# ADDENDUM NO. 1

## **Blue River Valley Schools Renovations to:**

## ADDENDUM ONE

**Addendum One (AD.01)** to the drawings and specifications prepared by Gibraltar Design for **Blue River Valley Elementary School and Jr/Sr High School Facility Improvements** for Blue River Valley Schools, New Castle, Indiana.

## UNIT "C" NEW LINTEL / CANOPY FRAMING PLAN

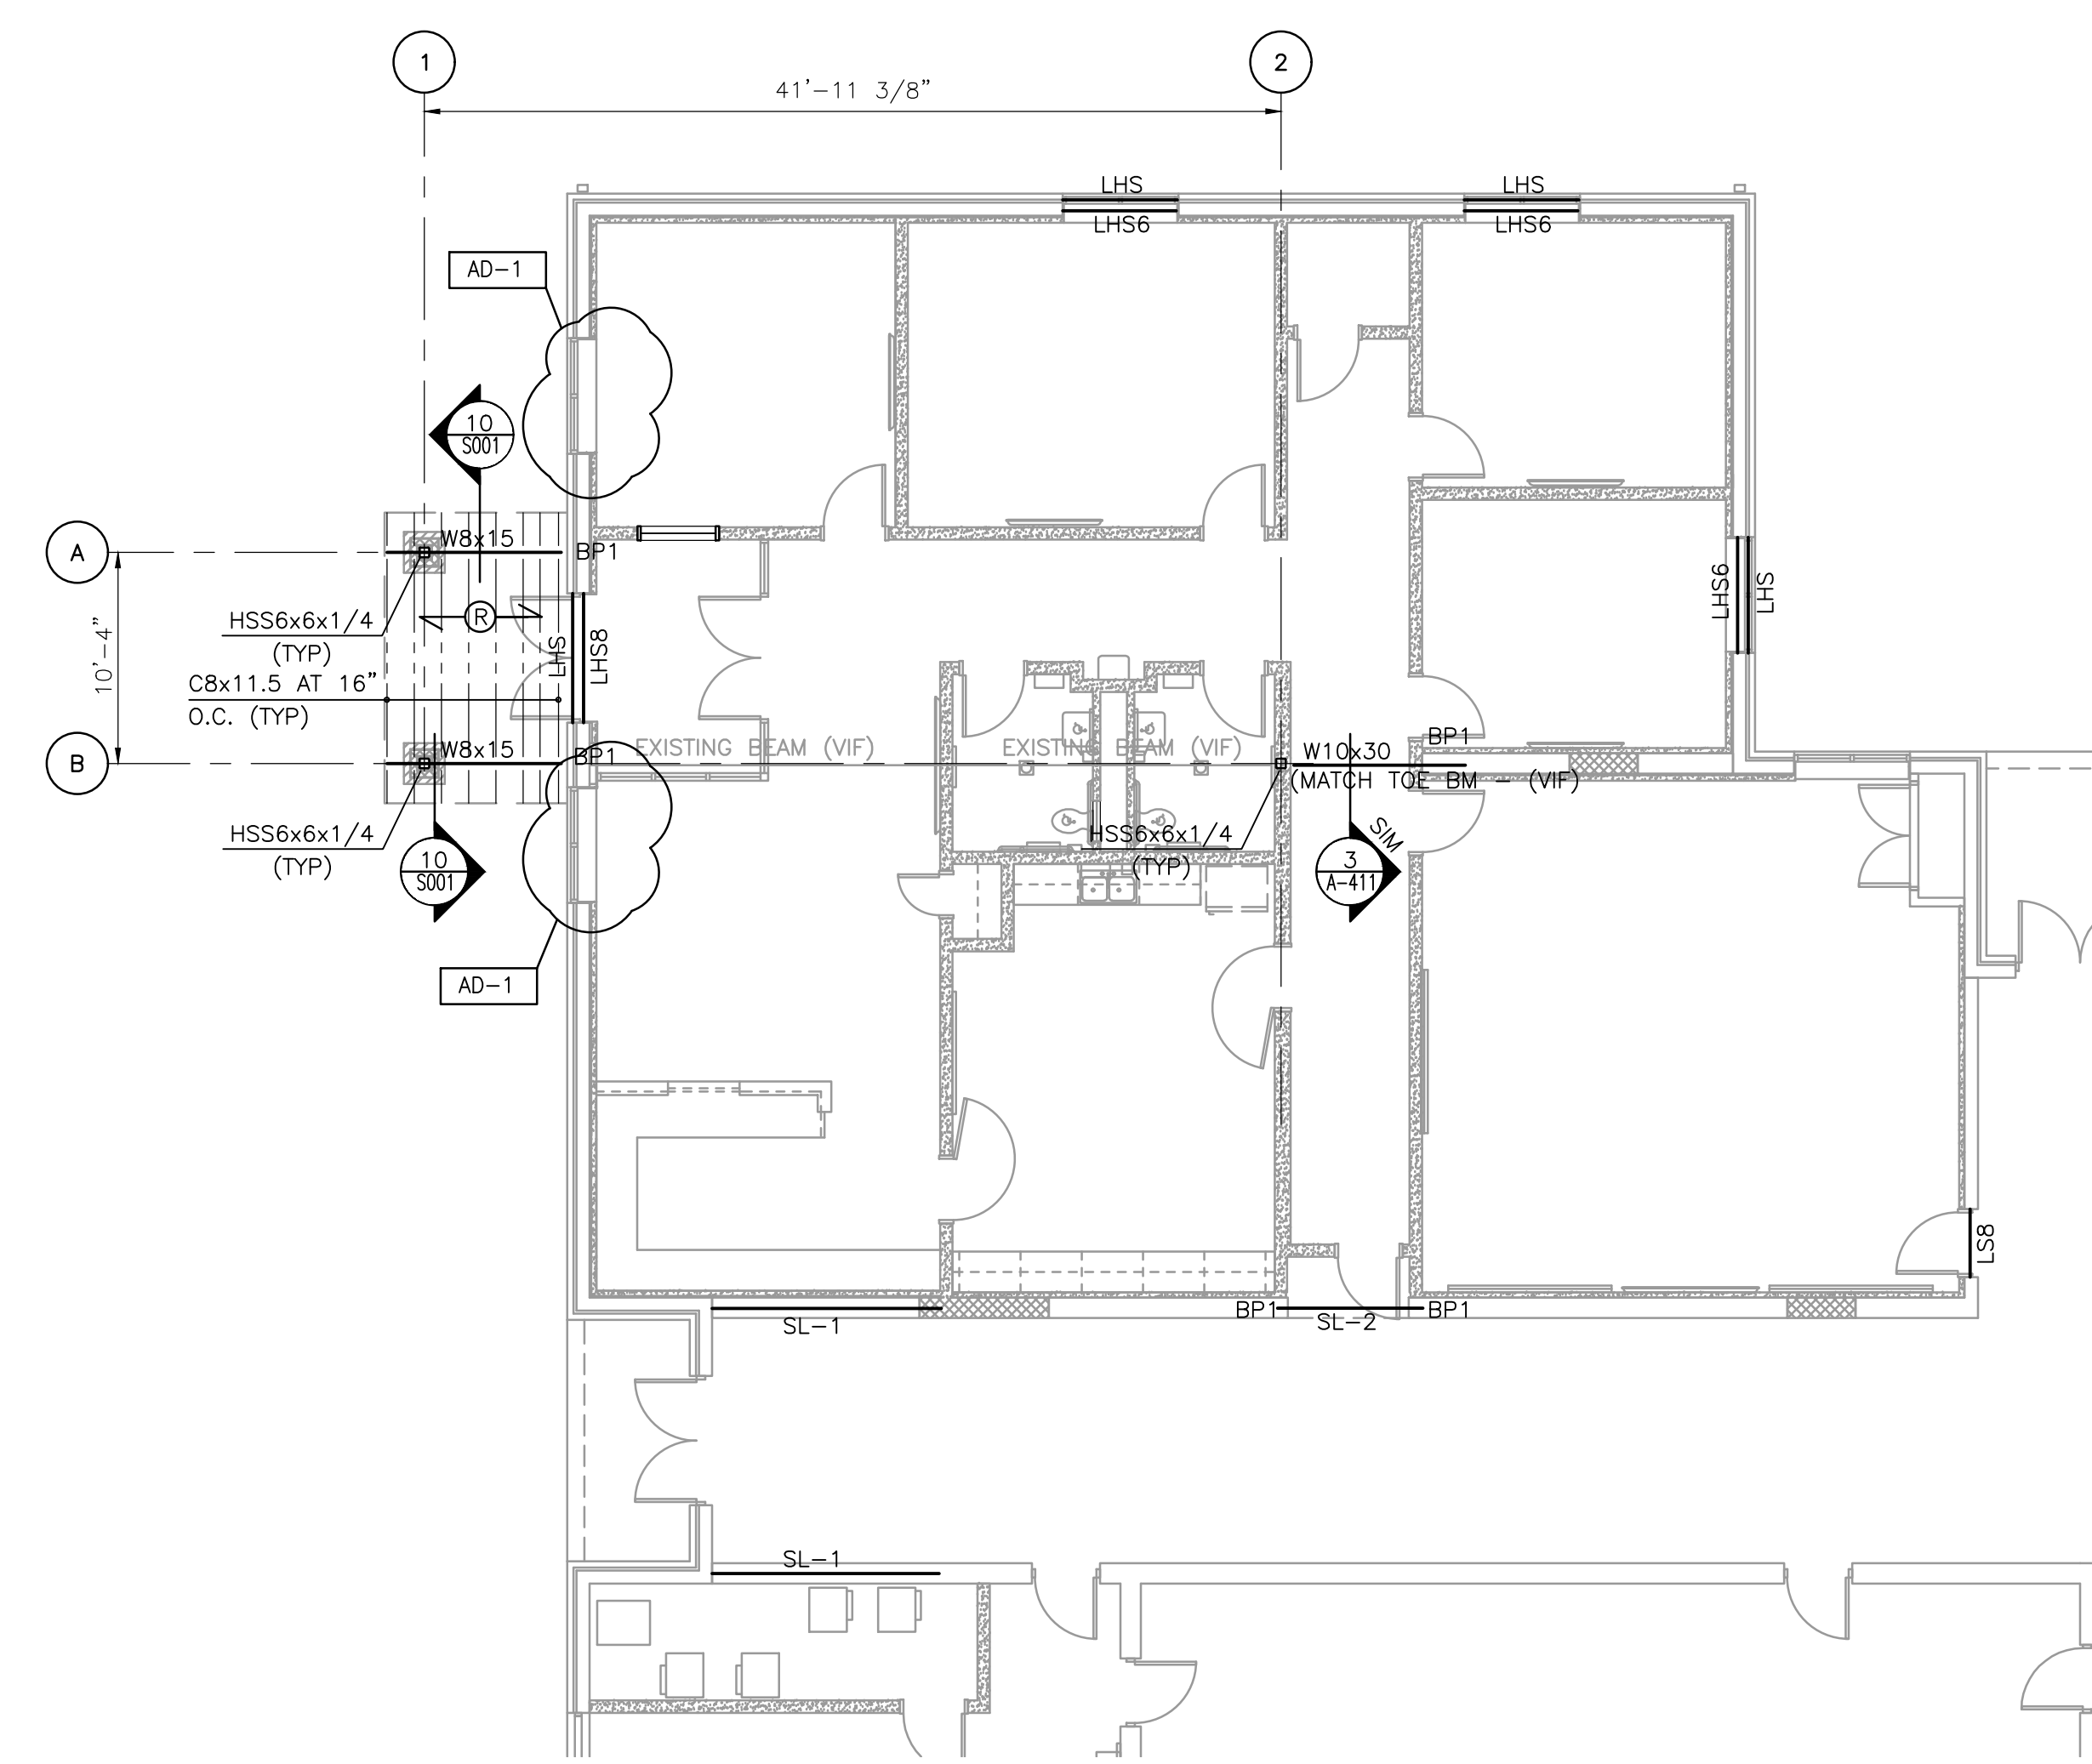
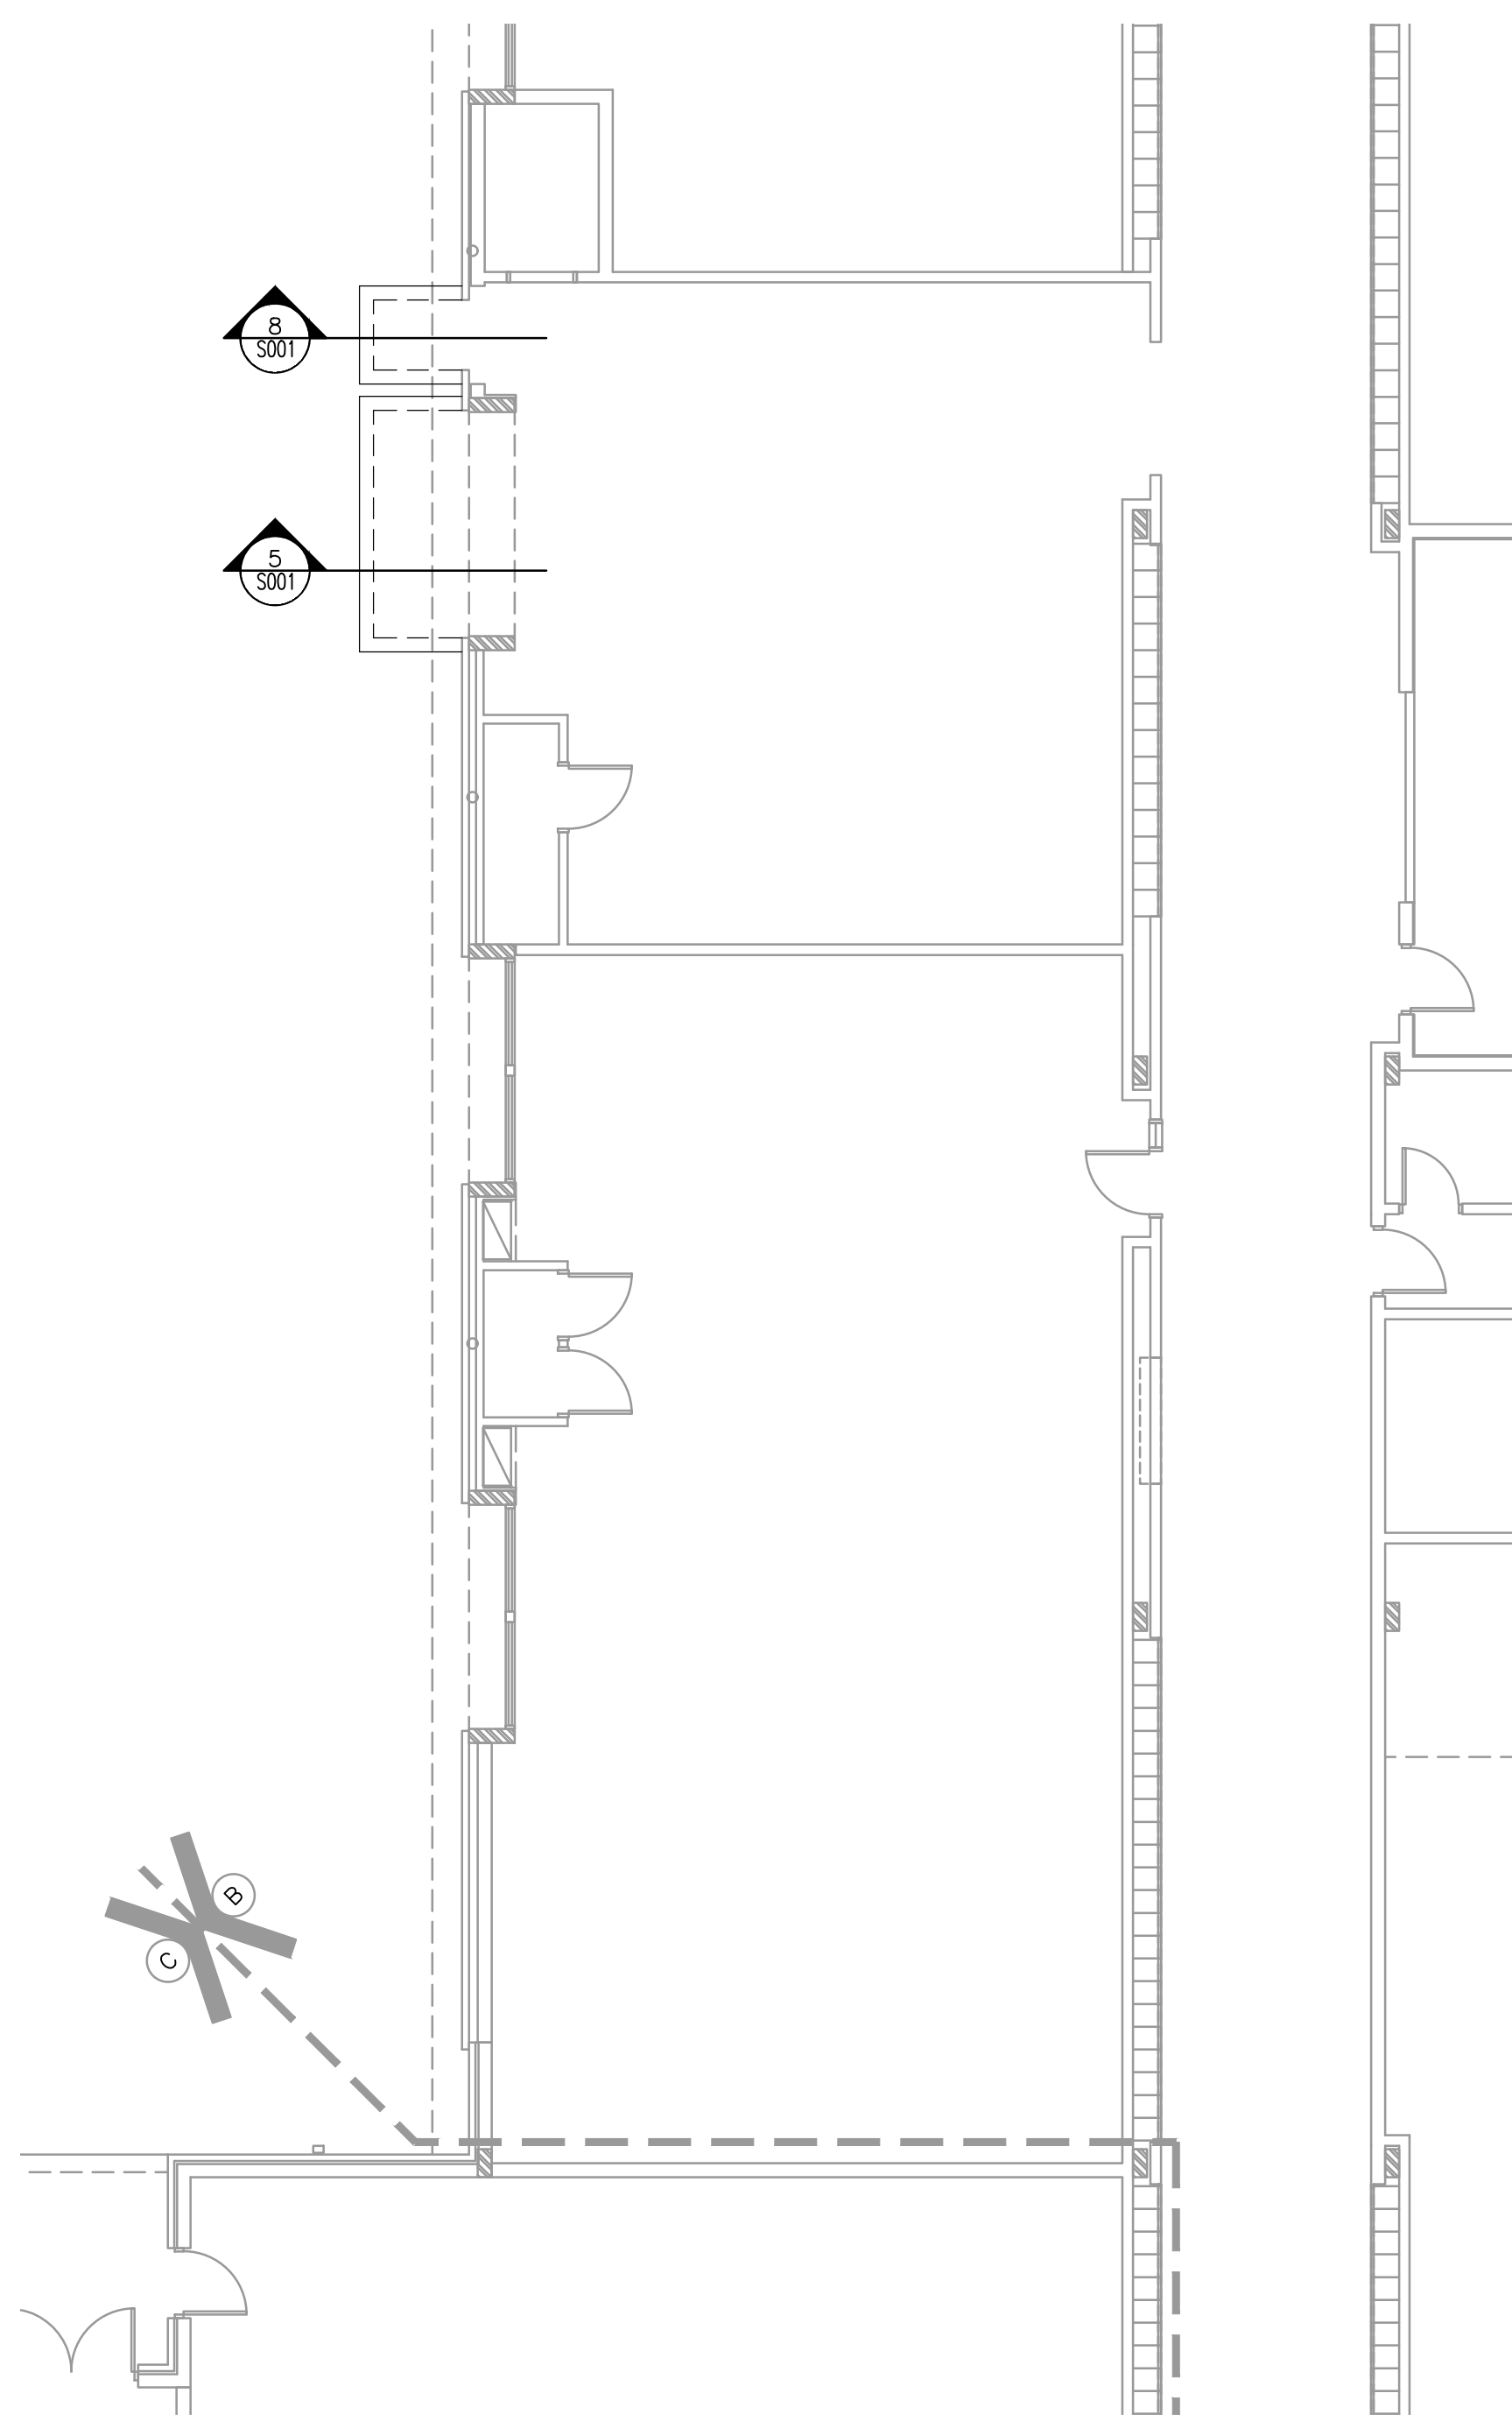
**3. Sheet S-101**

A. Refer to revised full size drawing included in this Addendum for the following revisions:

1. Remove new window lintels for Rooms C-108 and C-118 per "Unit 'C' New Lintel/Canopy Framing Plan" which are labeled as LHS & LH56.
